RE: WTC 776.00 Church Street Underpass
at Dey Street-New Escalators, Pre-
liminary Drawings, Borough of
Manhattan

We have completed our review of the preliminary contract drawings submitted with your letter of June 21, 1983. In keeping with our meeting of July 21, 1983, the following point by point discussion should clarify the comments in the marked-up set of plans we are returning.

FREDERICK NOVOTNY, P.E., CHIEF
Division of Sewer Regulation
and Control, Bureau of Sewers

DWG. NO. **R. 457**

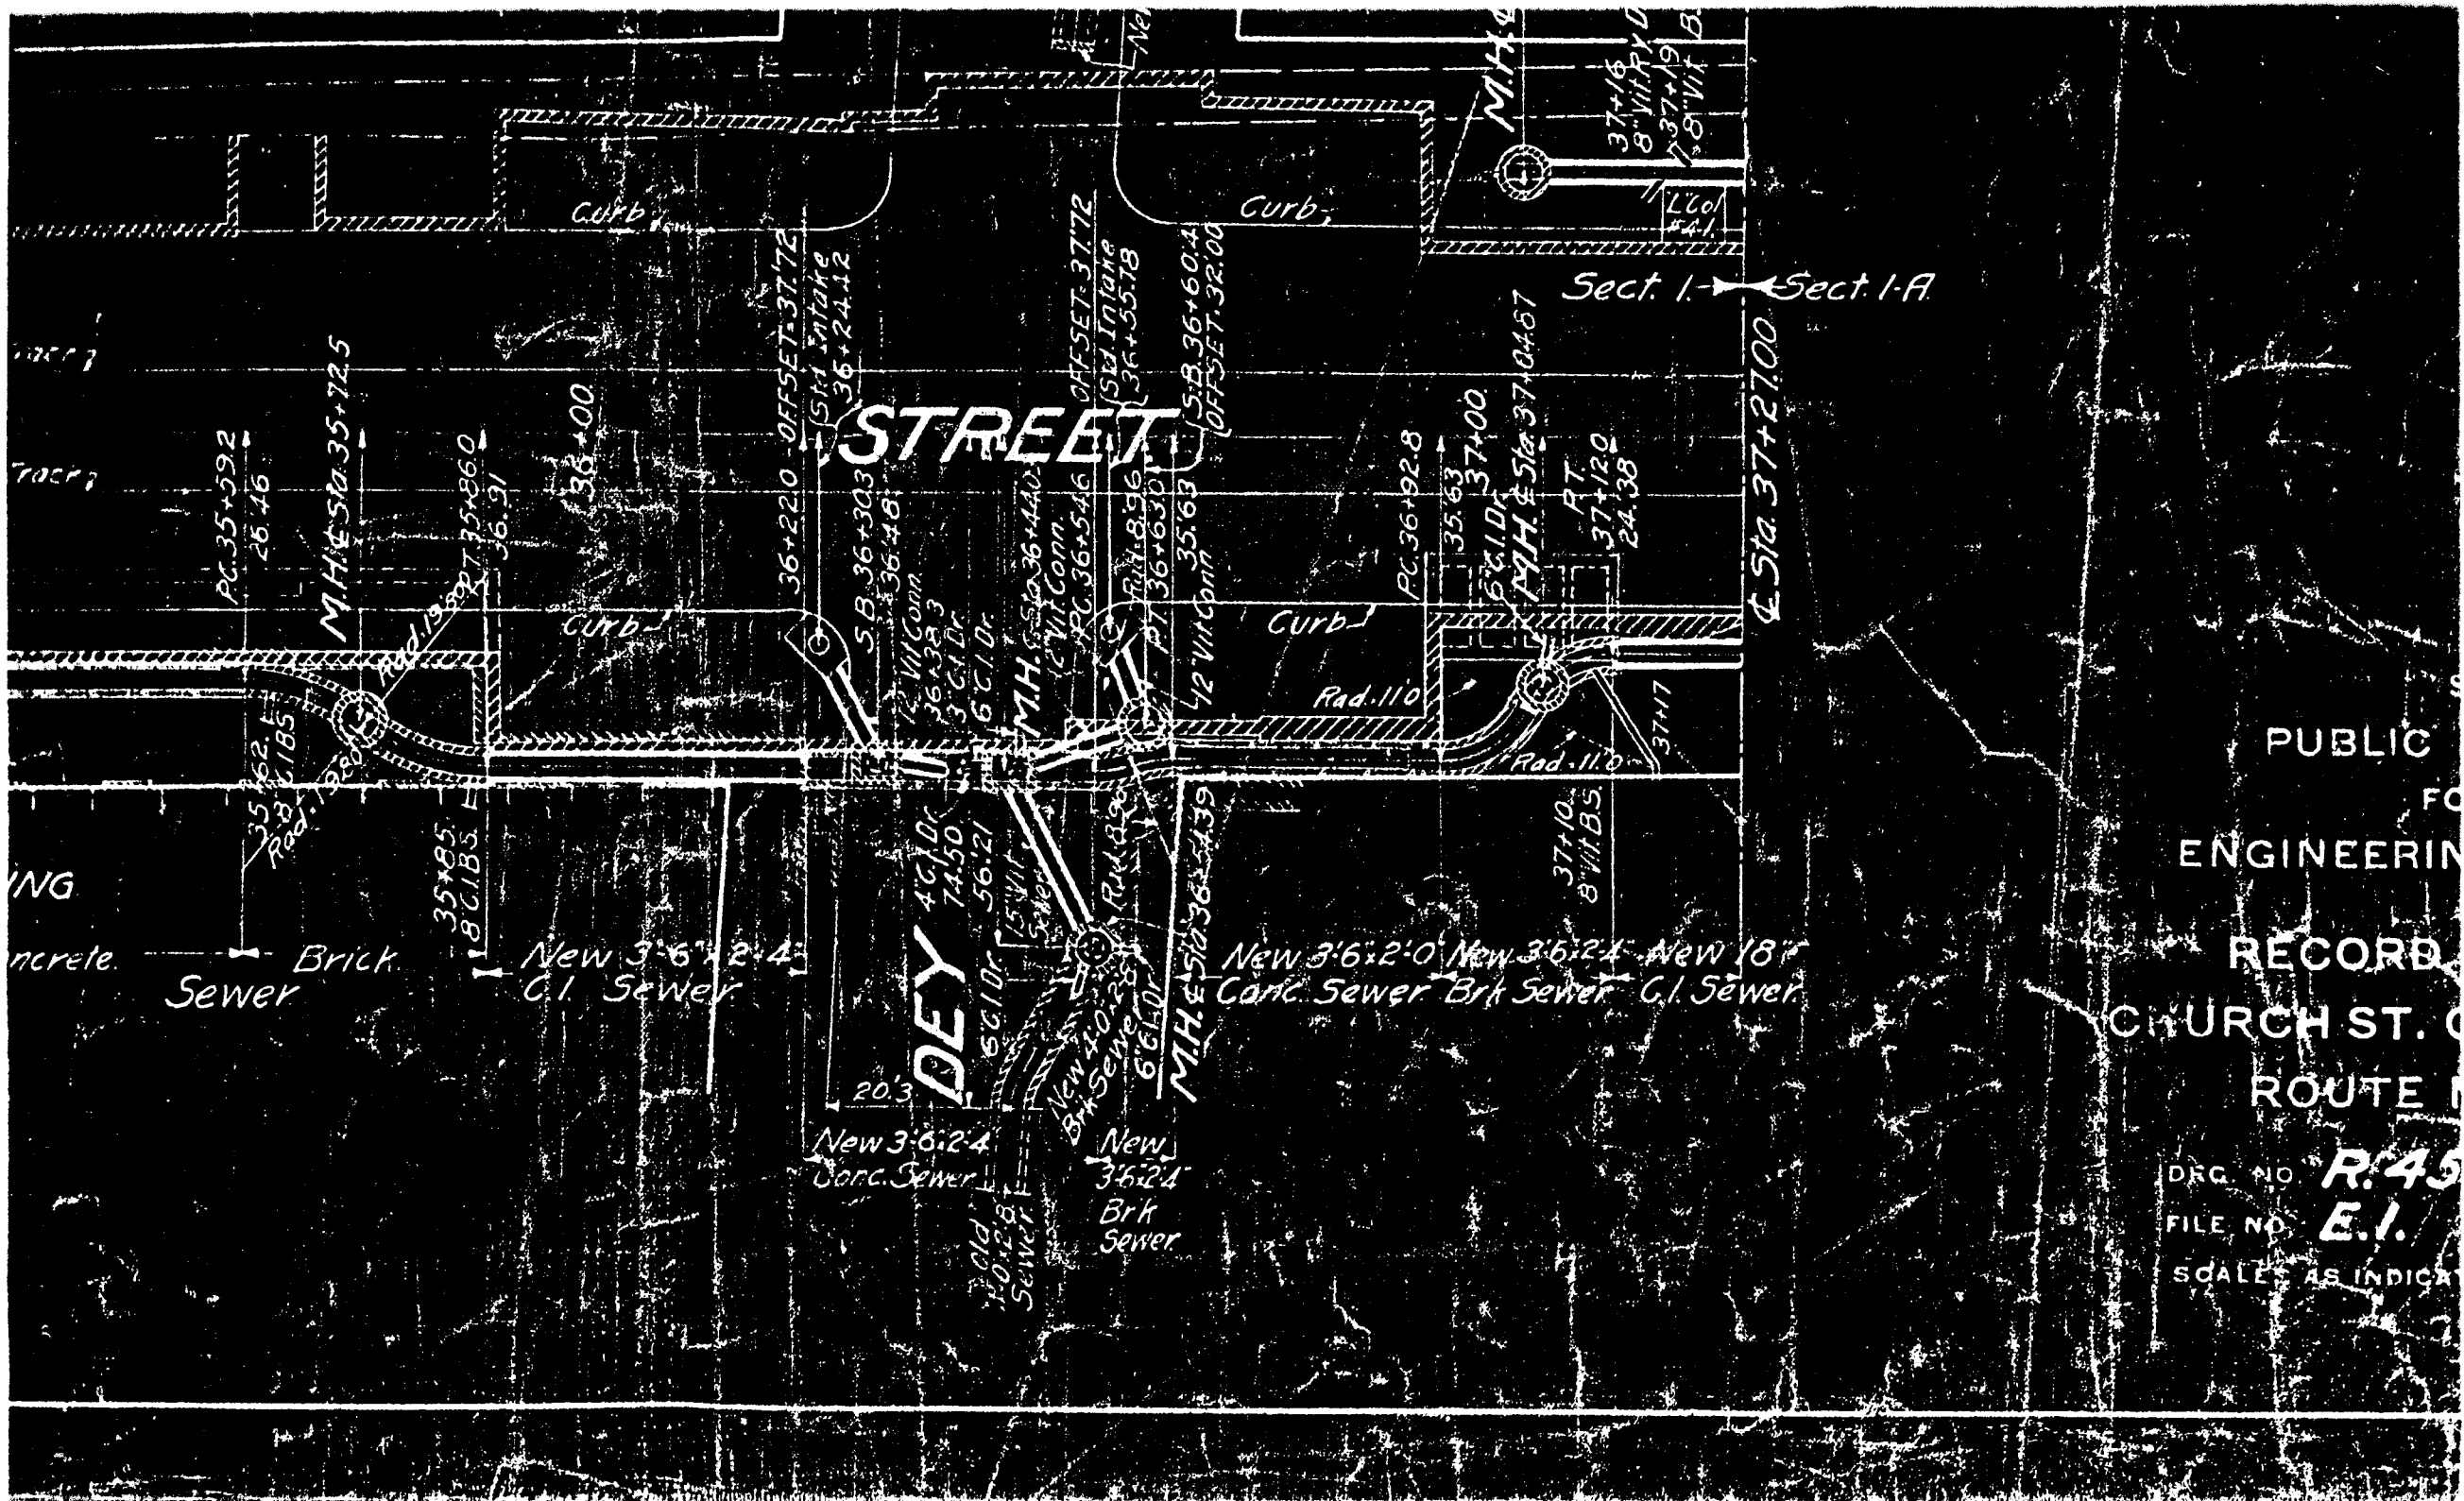
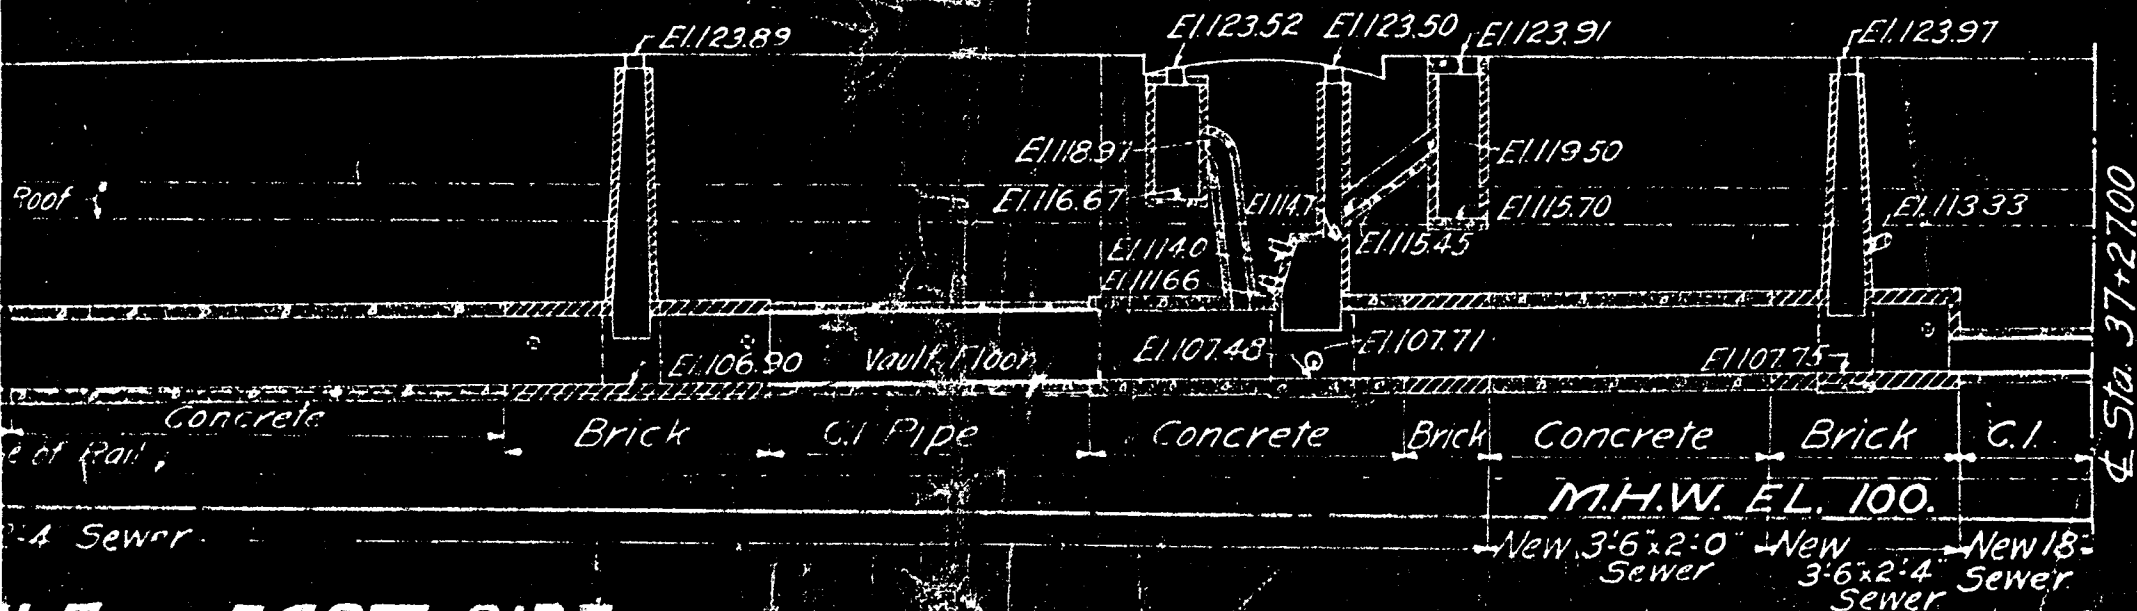
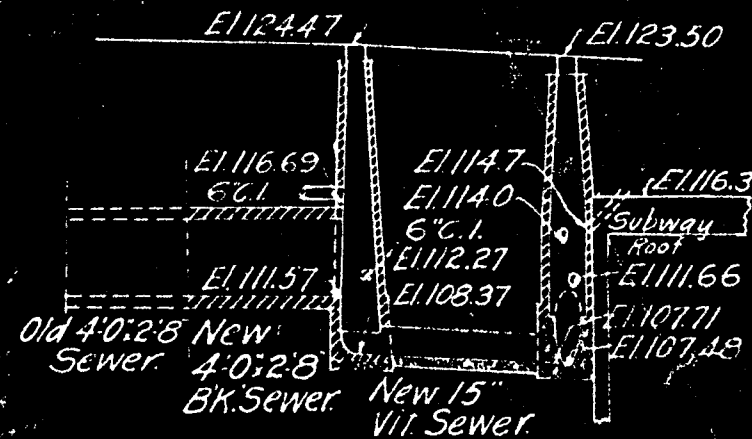
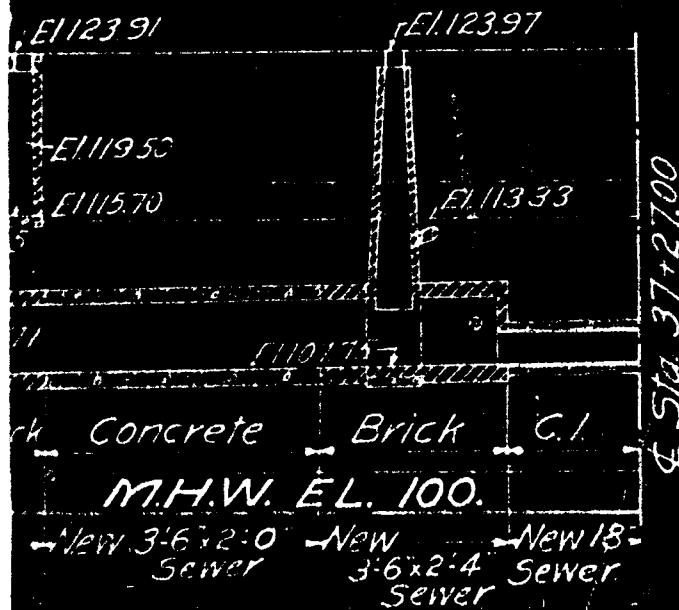
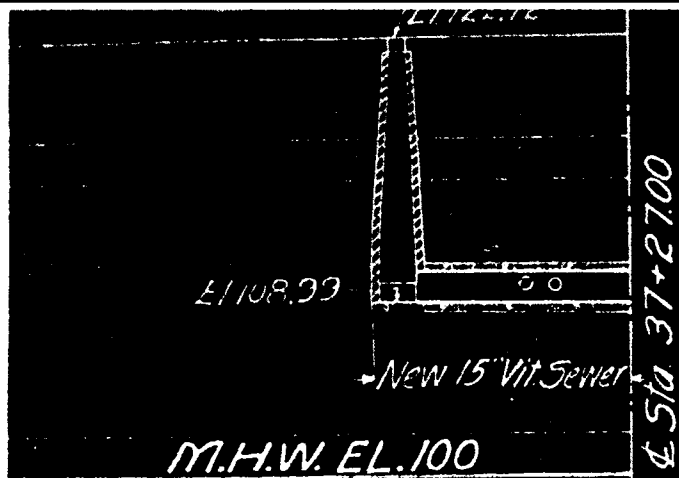
The submitted plans did not show provisions for support or replacement of the 3'-6" X 2'-4" sewer which runs along the east wall of the BMT Subway in Church Street. The affected area lies approximately between the north and south building lines of Dey Street. Sewer Record Drawing R457, Route 5, Section 1 dated June 19, 1916 shows three (3) distinct types of construction within these limits. Attached are xerox copies of pertinent sections of R457 for your information.

As we discussed in the July 21, meeting it does not seem likely that the brick and concrete sections of sewer can be supported during the proposed construction, i.e., underpinning of Citibank, driving of soldier beams and temporary support of the subway roof at the escalator opening.

- 1) A new special "L" shaped manhole would be constructed on the sewer at the north building line in place of proposed Manhole No. 3. Special attention would be given to the existing telephone ducts which may require partial relocation.
- 2) A new manhole would be constructed on the sewer at the transition to the special 3'-6" X 2'-4" Cast Iron Section located approximately 3.5 feet south of the south curbline.
- 3) The two catch basin cleanout manholes would be abandoned or removed as required. Two new catch basins should replace the corner Granite Head inlets. These basins would be connected directly to the new manholes described in 1 and 2.
- 4) Between the two manholes described in 1 and 2 the sewer will be replaced with a 36" Ductile Iron Pipe.
